Attachment D - Figure 8.0 - Nullarbor Prevention Arborist Area Plan

PLANS AND DOCUMENTS
referred to in the PDA
DEVELOPMENT APPROVAL

Approval no: **DEV2019/1061**

Arborist Area Plan Herston Quarter
Stages 4A & 4B (Services Diversion
Works & New Northern Carpark)

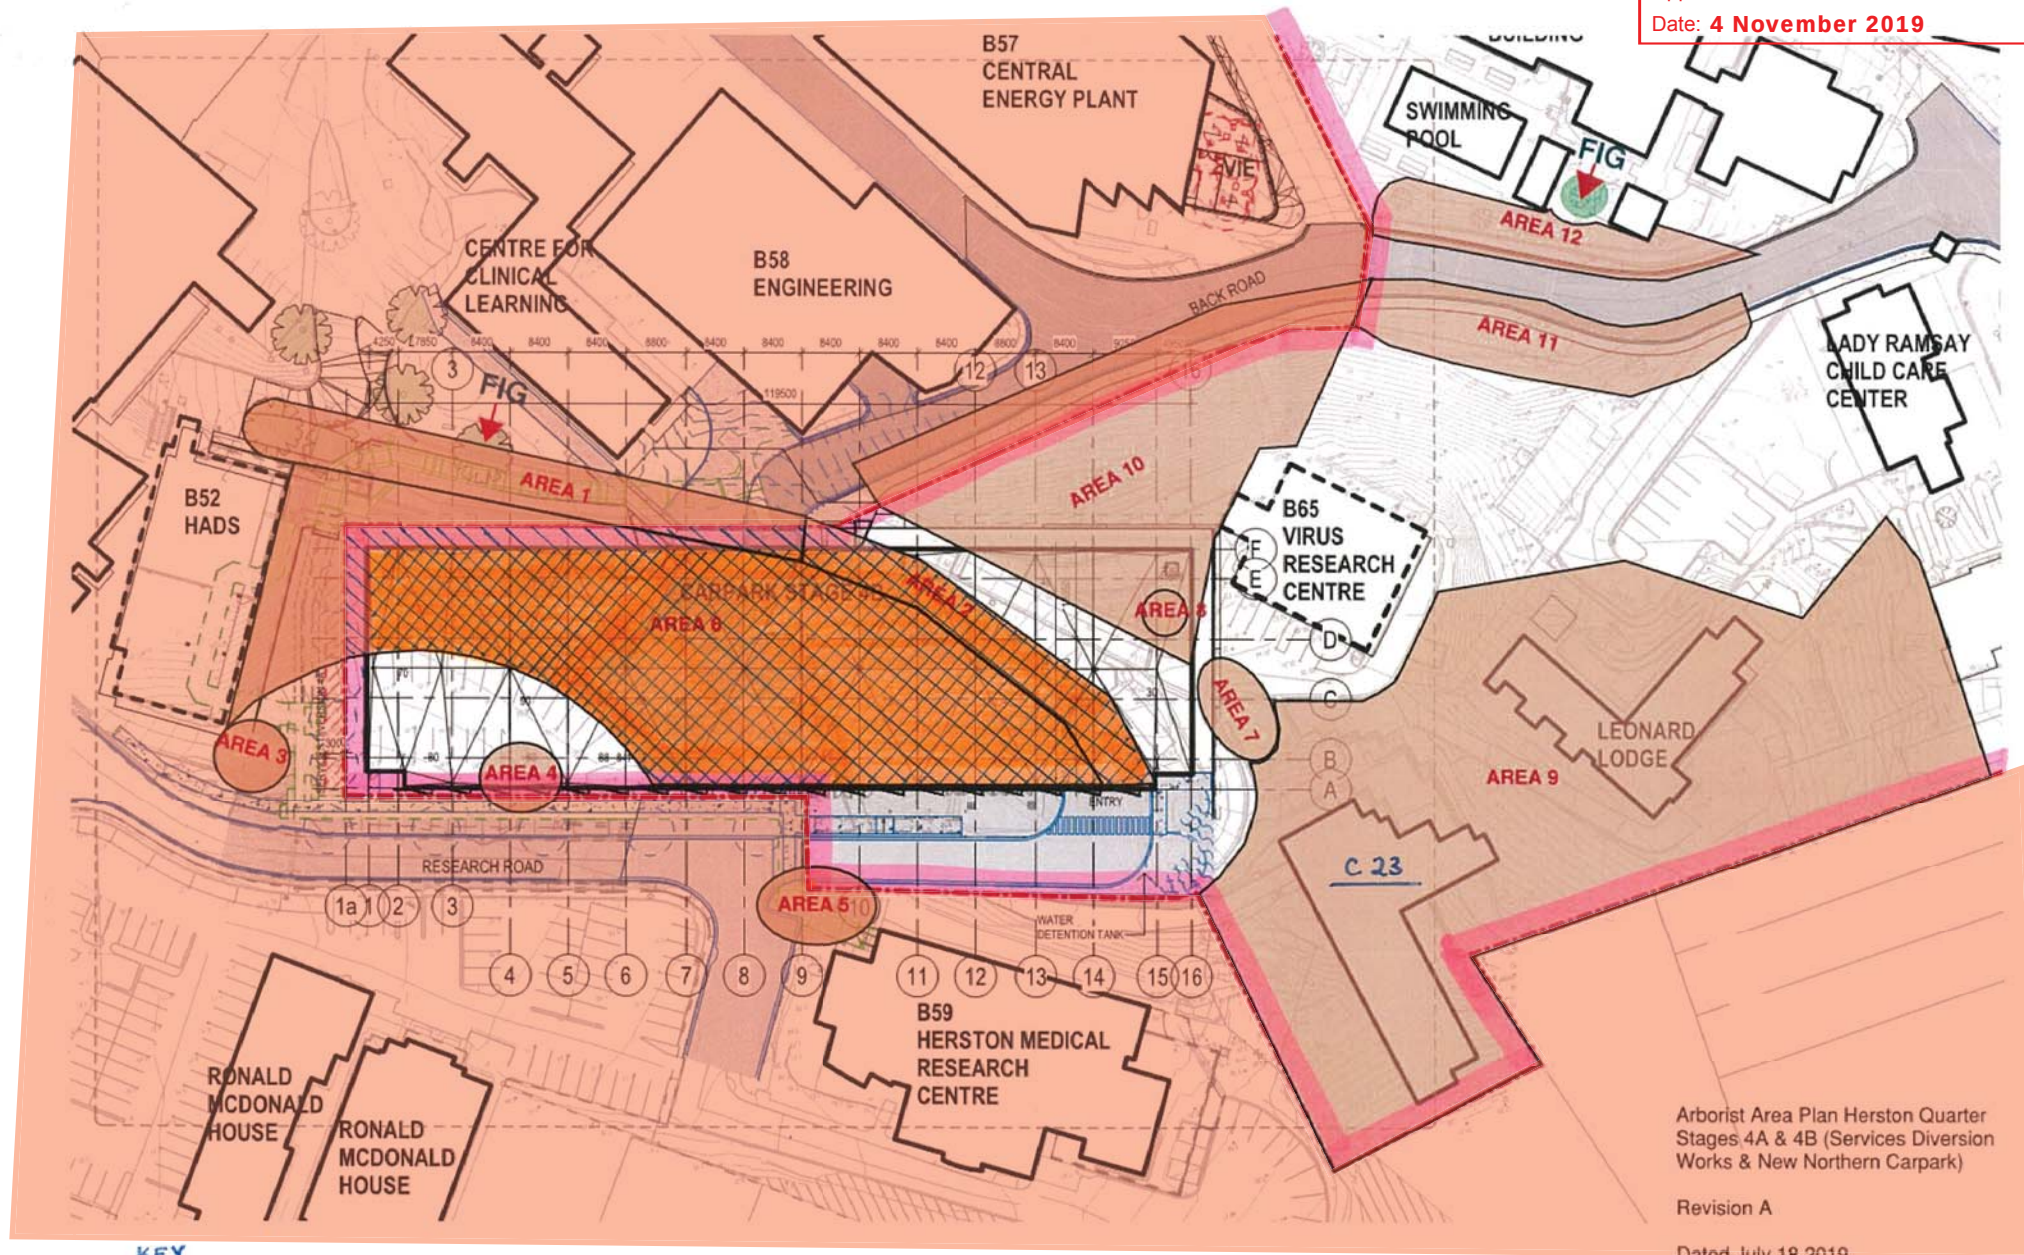
AMENDED IN RED

Attachment D – Figure 5.0b – Earthworks Plan (Sheet 1)

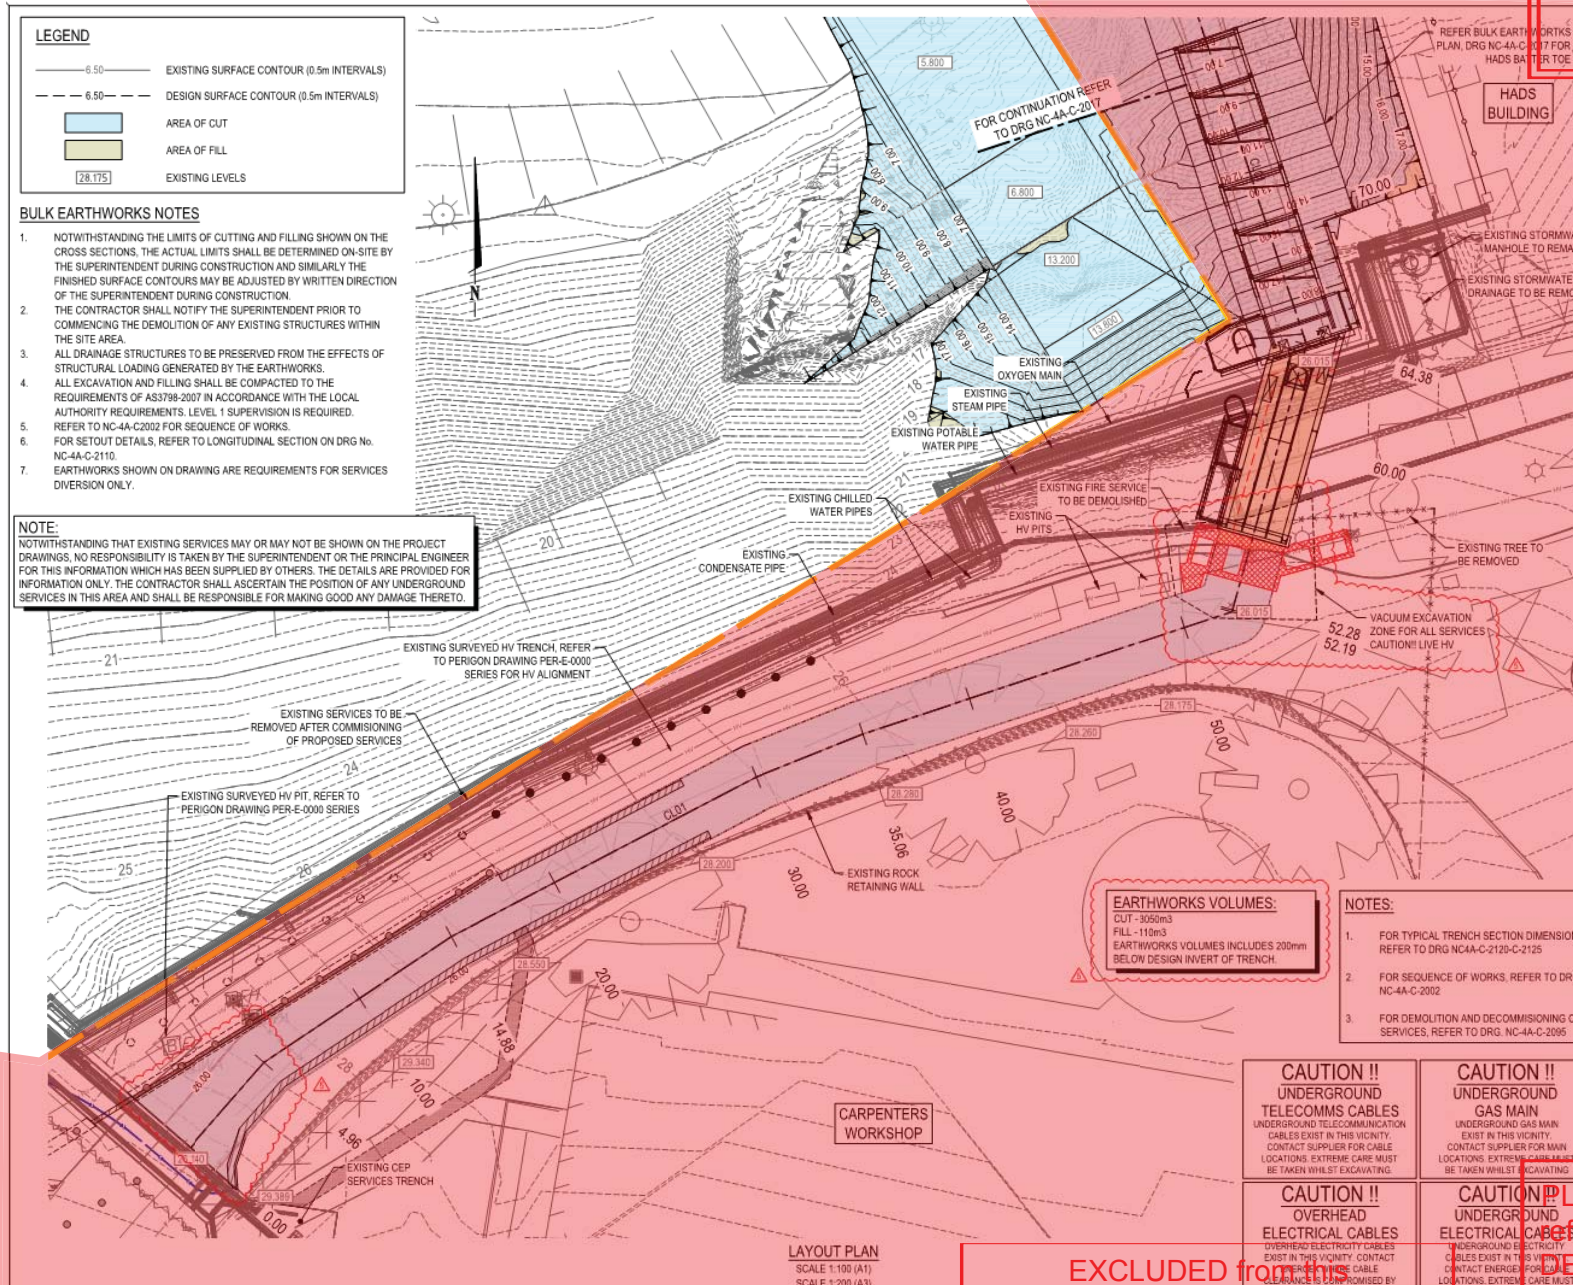
AMENDED IN RED

EXCLUDED from the
PDA DEVELOPMENT APPROVAL

Attachment D – Figure 5.0c – Earthworks Plan (Sheet 2)

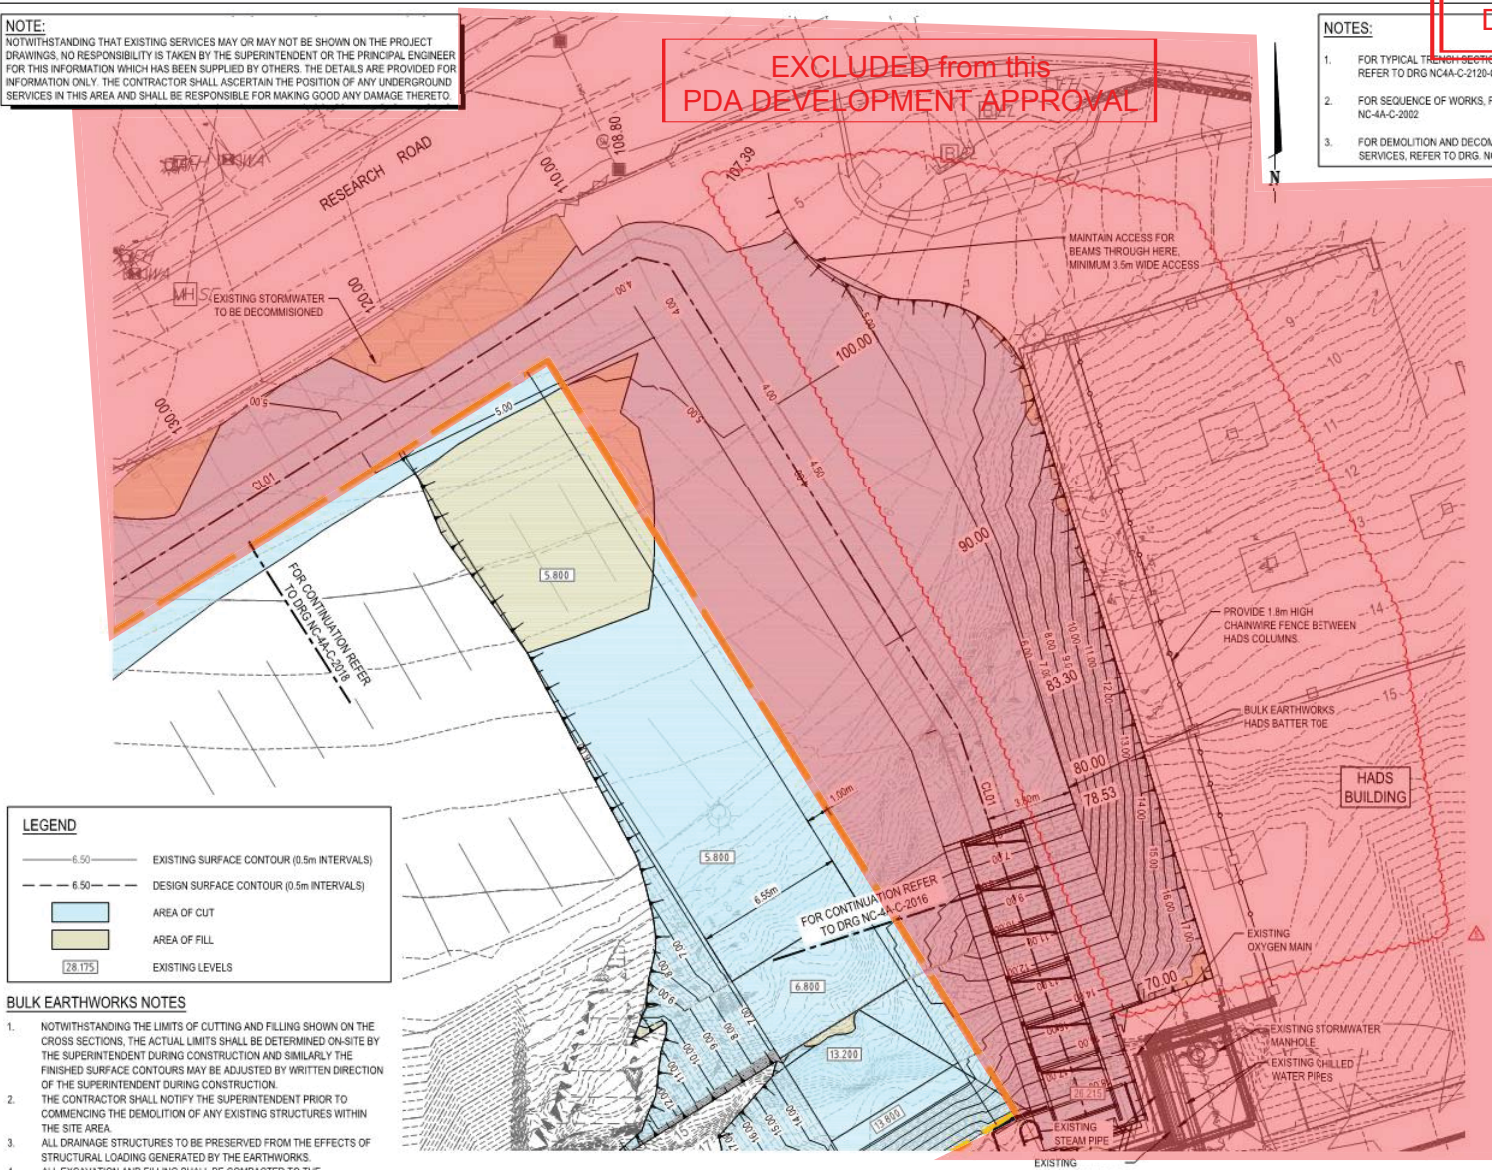
AMENDED IN RED

EXCLUDED from this
PDA DEVELOPMENT APPROVAL

Attachment D – Figure 5.0d – Earthworks Plan (Sheet 3)

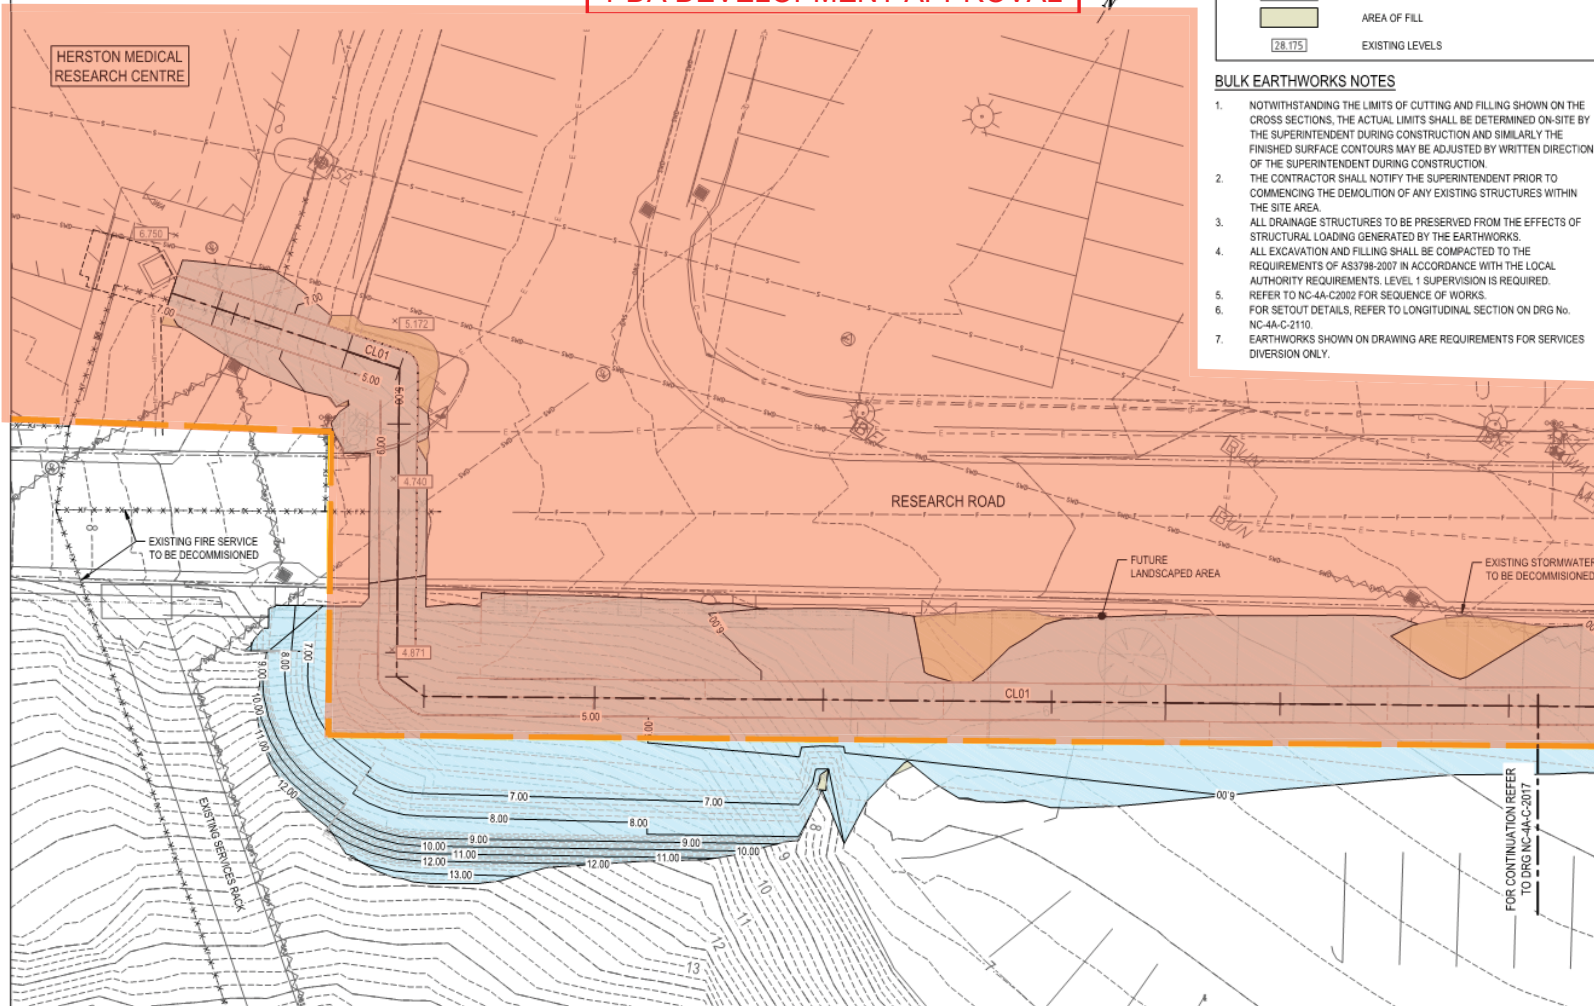
AMENDED IN RED

EXCLUDED from this
PDA DEVELOPMENT APPROVAL
